UNITED STATES PATENT AND TRADEMARK OFFICE

10/643,878

Office Action Summary	Application No. 10/643,878	Applicant(s) FOLEY ET AL.	
	Examiner Anu Ramana	Art Unit 3733

DETAILED ACTION

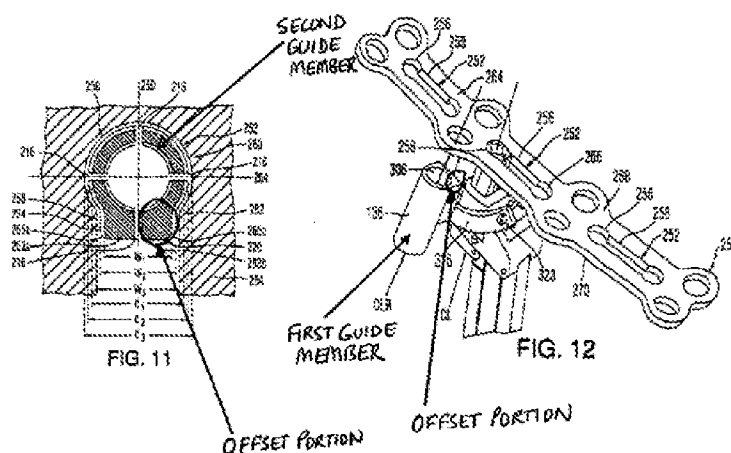
Brace et al. disclose a drill guide assembly for use with a bone plate to correctly seat screws in the bone plate, the assembly including: a first guide member 136 and a second guide member 206 extending from a handle 126; each of the guide members having an offset portion adjacent a distal end of the guide member; each of the guide members having a main body portion of a first width, an intermediate portion having a second width less than the first width, and the slot engaging end having a third end less than the second width; and wherein the guide members are configured and dimensioned to fit bone plate fastener holes having an elliptical shape (Figs. 1-2, 6 and 10-12 and cols. 5, lines 19-67 and cols. 6-14). See marked up Figs. 11 and 12 from Brace et al. below.

Regarding claim 27, the guide members 136 and 206 are asymmetrical with respect to each other.

Contrary to Applicant's arguments, the Examiner notes that Brace et al. (US 6,342,057) clearly disclose drill tube 136 and bushing 206 to have offset portions (see marked up Figures provided in this action). It is also noted that a claim containing a "recitation with respect to the manner in which a claimed apparatus is intended to be employed does not differentiate the claimed apparatus from a prior art apparatus" if the prior art apparatus teaches all the structural limitations of the claim. Ex parte Masham, 2 USPQ2d 1647 (Bd. Pat. App. & Inter. 1987).
